# Product Change Notification

**Change Notification #:** 108391 - 01  
**Change Title:** Intel 10 Gigabit XF SR Server Adapter, EXPX9501FXSRGP5 MM#893132 (Bellefontaine OEM generic) and 10 Gigabit XF SR Dual Port Server Adapter, EXPX9502FXSRGP5 MM#893135 (Green Fountain OEM generic)

**Add Drop in Replacement Voltage Regulator and Add Product ID Label to Single Pak Box**

**Picture 1, Product ID label on outside of Single Pak box, example only.**

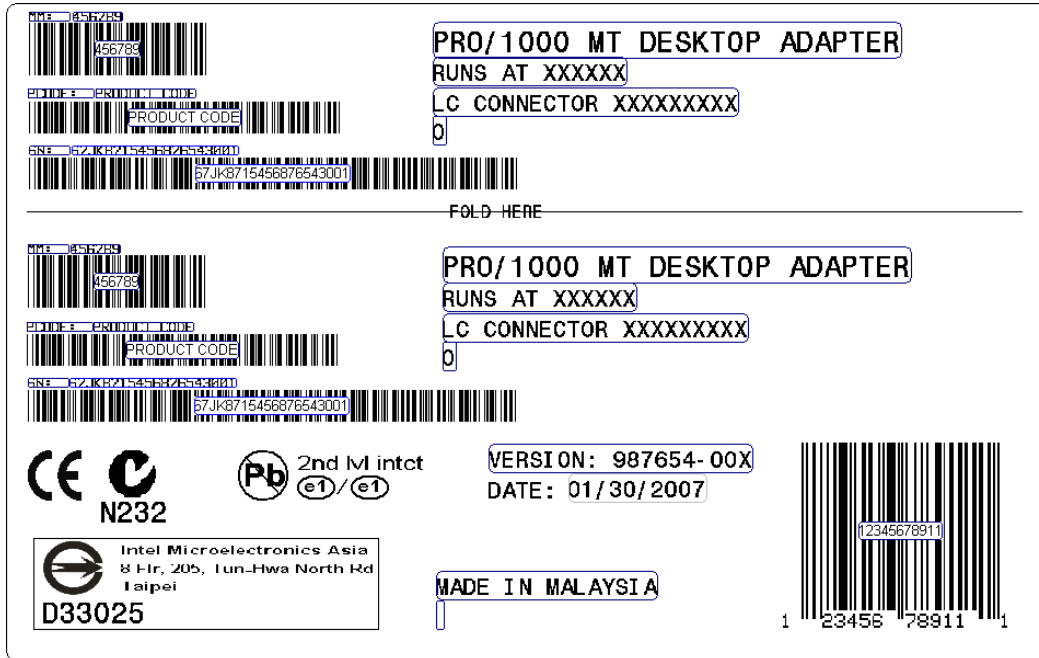
A Product ID label will be added to the outside of the Single Pak box, as noted in the pictures below.
